INDESIT company

Model type:
LV640AIX

Commercial code:
F029946

n1045069: Modification of racks and dispenser lid on EVO3 dishwashers

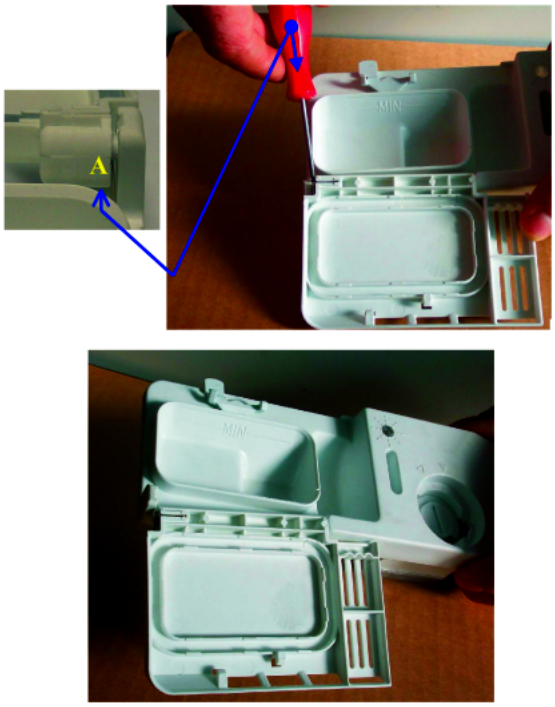
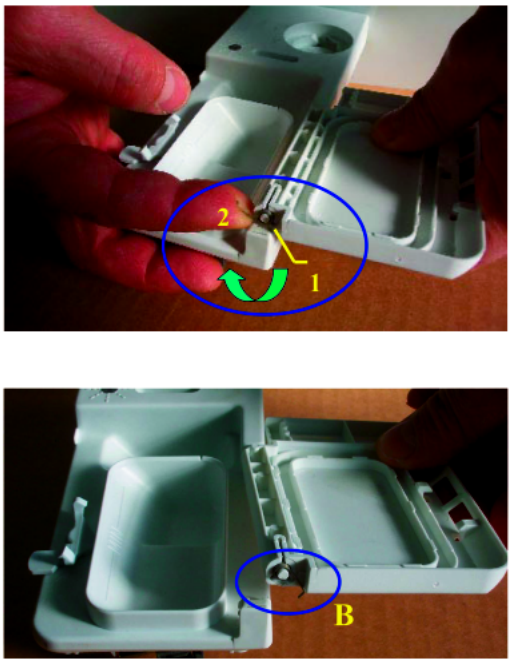
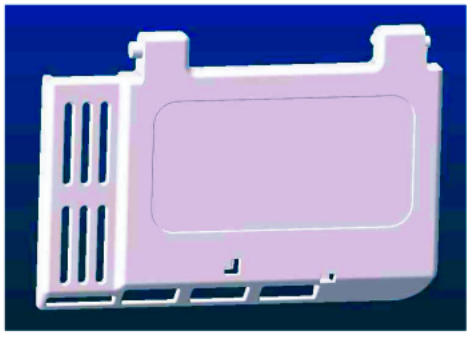
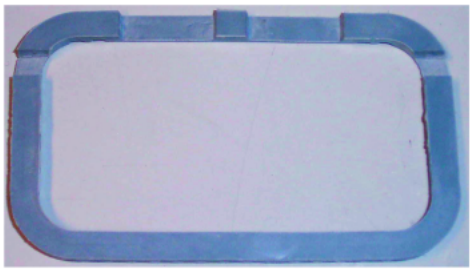
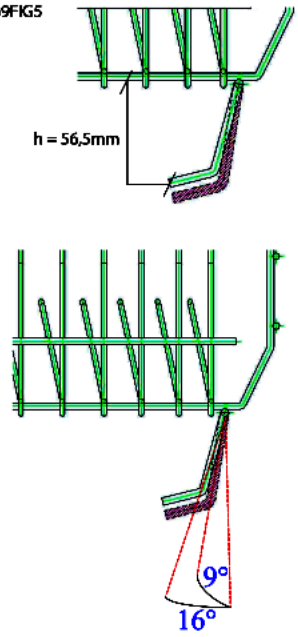
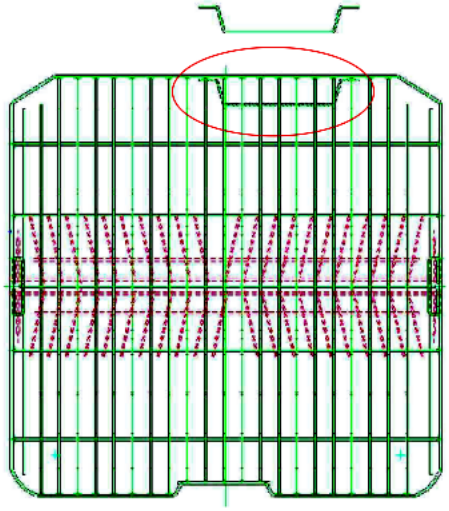
To obtain better dissolving of the detergent during the wash cycle, the following modifications have been made to EVO3 dishwashers:
- new dispenser lid, replacement code 098134 (see figure N1045069FIG4) created;
- upper racks modified with lid catch angle changed from 9° to 16° (see figure N1045069FIG5);
- MultiSystem lower racks modified with insertion of a spacer wire at the electric dispenser (see figure N1045069FIG6).

Lid installation instructions:
1) prise the lid out of the dispenser seat using a small screwdriver at point A (figure N1045069FIG1);
2) replace the lid, checking that release spring B (figure N1045069FIG2) is in place; before fitting the new lid load the spring from position 1 to position 2 (figure N1045069FIG2);
3) fit the lid in its special seat and check for correct operation (figure N1045069FIG3).
Lid closing may be harder for the first few cycles after replacement, due to settling of the material.

The upper and lower racks have the same spare part codes as the premodification items; Replacements Warehouse stocks have been replaced.

N1045083FIG1

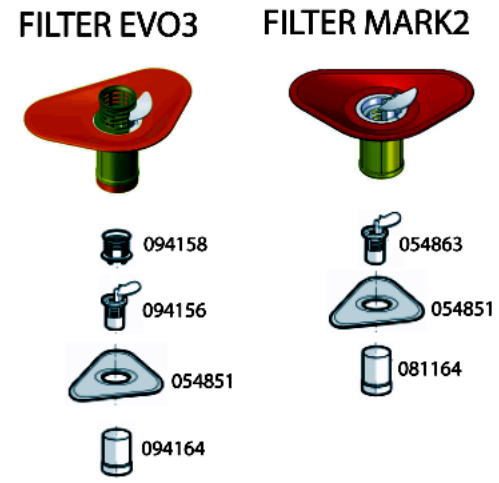
All dishwasher models affected by this modification have been equipped with the items listed below, in order to solve the drain pump clooging problem.

Introduction of:
Cylindrical plastic filter code 081164
Central filter code 054863

Elimination of:
Cylindrical plastic filter code 094164
Central filter code 094156
Central filter grid code 094158

The modification has been introduced progressively, starting from serial no. 40516.0001.

n1045085: Introduction of new litre counter turbine integrated on air-break.

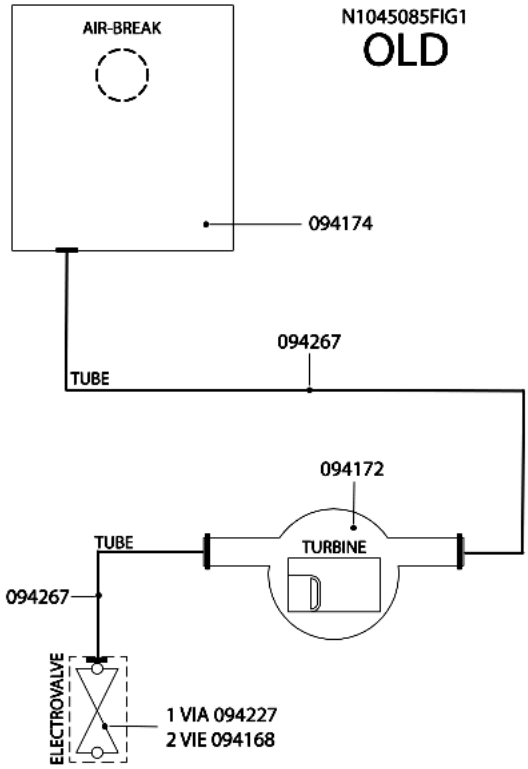
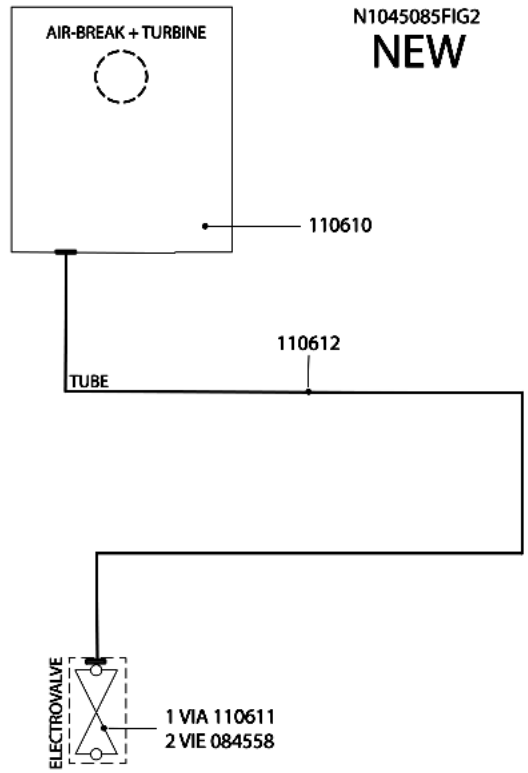
All dishwashers affected by this note have been equipped with a new litre counter turbine on the air-break.
Picture N1045085FIG1 illustrates the premodification structure, picture N1045085FIG2 the new structure.

AIR-BREAK:
new 110610;
premodification 094174;
the new item features a new integrated litre counter turbine and its water supply hose has a smaller diameter.

LITRE COUNTER TURBINE code 094172 has been eliminated.

SOLENOID VALVES:
new:
1-WAY code 110611;
2-WAY code 084558(Rohs 143737);
premodification:
1-WAY code 094227;
2-WAY code 094168;
the new solenoid valves have a smaller diameter drain hose fitting.

HOSES:
new solenoid valve hose/air-break code 110612;
premodification turbine hose/air-break code 094267;
premodification solenoid valve hose/air-break code 094267;
the new hose has a smaller internal diameter.

WIRING:
the litre counter turbine connecting cable is longer, but since the connector is the same, the new item can be used in place of the premodification one.

N1045093FIG1
NEW FLAP UPPER BASKET SAT CODE 114799

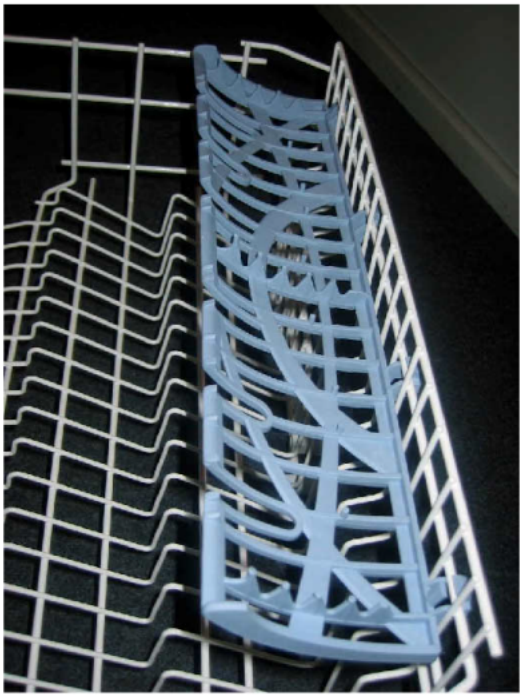
From serial no. 41109.0001 all models affected by this bulletin feature a modification of the folding shelf to upper basket coupling system.
This modification called for alteration of the relative baskets: the distance between the wire on which the folding shelf is attached and the wire below it has been increased from 9.5 mm to 17 mm, as shown in the attached image.
The altered folding shelves are not interchangeable and cannot be installed on premodification baskets: in the case of service interventions on product with serial number prior to 41109.0001 the entire upper basket must be replaced.
The baskets are reciprocally interchangeable and are managed as assemblies complete with their accessories, inclusive of folding shelves.

UPPER BASKET LIGHT BLUE FOLDING SHELF
new 114799 - premodification 094140.

UPPER BASKET ASSEMBLIES
new 115001 - premodification 094139;
new 115002 - premodification 094222;
new 115003 - premodification 094233.

N1045076FIG1

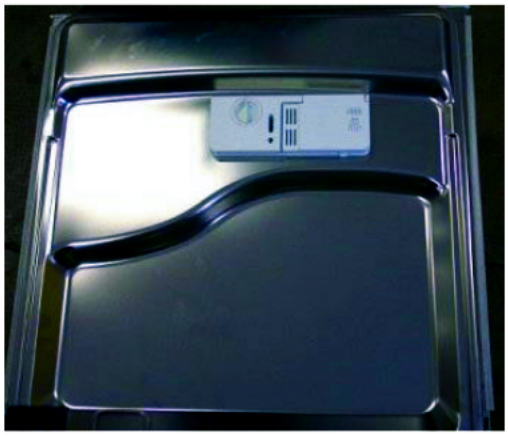
From serial number 50930.0001, to solve the problem of water spurts emitted from the lower right and left side of the door the following modifications were introduced in production:

1-Airbreak without insert to allow the necessary pressure venting

2-Honeycomb top panel to protect the kitchen unit from any steam emitted (only on built-under models)
3-Tank seal length increased by 3 cm to improve water tightness
4-Die-cut roof sound-deadening panel
5-Three clips for correct fixing of the tank base seal (in production from serial number 50701.0001)

New parts:
C00141308 - Airbreak
C00141310 - Honeycomb top panel (built-under versions only)
C00141317 - Tank seal
C00141314 - Roof sound-deadening panel
C00140679 - Tank base seal fixing clip

Premodification parts
C00110610 - Airbreak
C00116110 - Tank seal
C00097300 - Roof sound-deadening panel

1) AIRBREAK REPLACEMENT
It is mandatory to use the new part; in the event of replacement with premodification appliances proceed as follows:
- replace the airbreak with the new part C00141308
- if present, refit the roof sound-deadening panel after cutting out a 10x10 cm square from the rear left-hand corner
- on the built-under version, fit honeycomb panel C00141310 on the top of the appliance
- replace tank seal with the new seal P/N C00141317

WARNING: when replacing an airbreak without a litre-counter turbine use exclusively the same type of part (P/N C00094174 - all the relevant details are given in bulletin n1045085)

2) CHANGING THE TANK SEAL
On appliances with serial number from 40101.0001 to 50930.0001, you can use the new tank seal P/N C00141317 after cutting 1.5 cm off each end.

N1045133/134FIG1

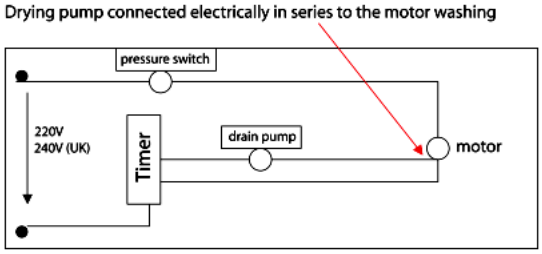
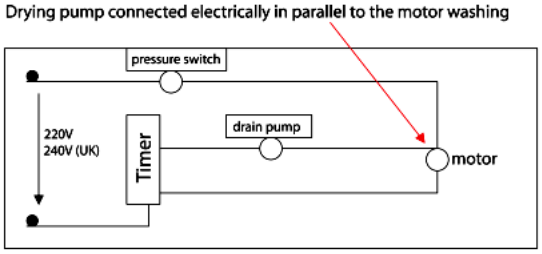
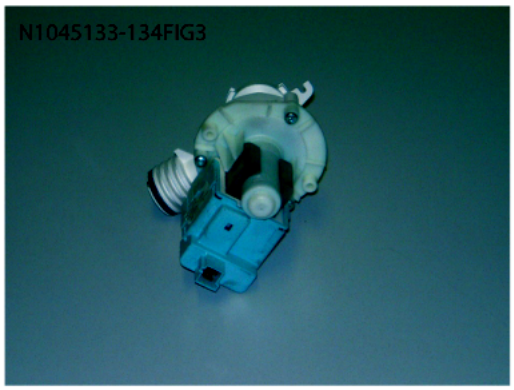
The drain pump electrical connection has been modified from a configuration in series with the wash electric pump to one in parallel.

The drain pump in series with the wash electric pump is fed through the wash electric pump causing a voltage drop equal to -15V (diagram N1045133-134FIG1).

The drain pump in series with the wash electric pump is electrically fed directly by the F-N line, without any voltage drop (diagram N1045133-134FIG1).

New parts:
Wiring in parallel
C00118767(Rohs 143766) - thermoprotected drain pump 220/240V 50HZ 26W - picture (N1045133-134FIG3)

Premodification parts:
Wiring in series
C00112306(Rohs 143739) - drain pump 230V 50HZ 22W - picture (N1045133-134FIG4)

Important!!
The thermoprotected drain pump cannot be installed on premodification dishwashers.
The non-thermoprotected drain pump cannot be installed on modified dishwashers.

N1045136FIG1

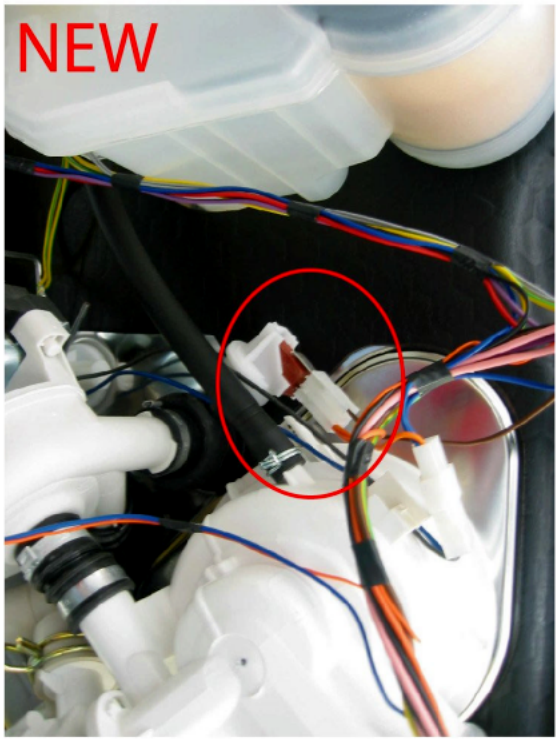
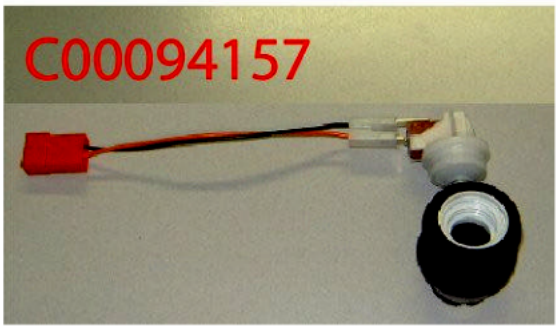
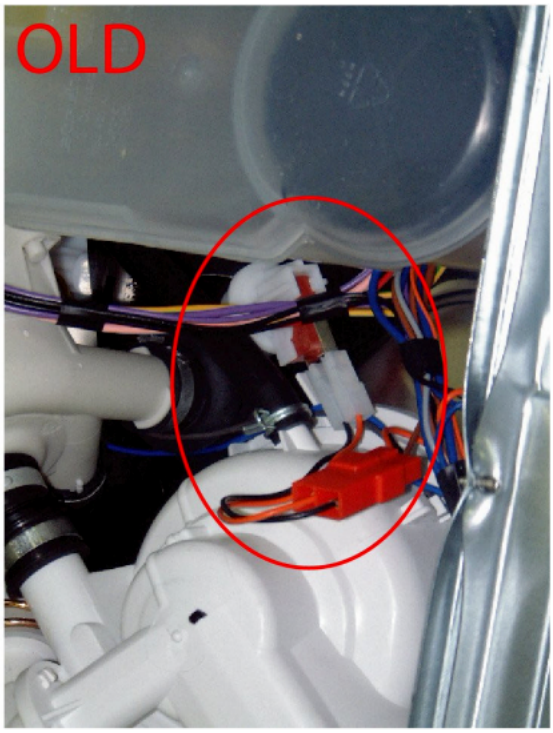
In modified products the connector going to the high pressure sensor is part of the wiring assembly (see picture N1045136FIG1). In premodification products the high pressure sensor is connected to the wiring assembly by a cable that is part of code C00094157 (see pictures N1045136FIG2-3).

New parts
Wiring
C00142435 - high pressure sensor

Premodification parts
Wiring
C00094157 - high pressure sensor + cable

The new parts are not individually interchangeable with premodification ones.
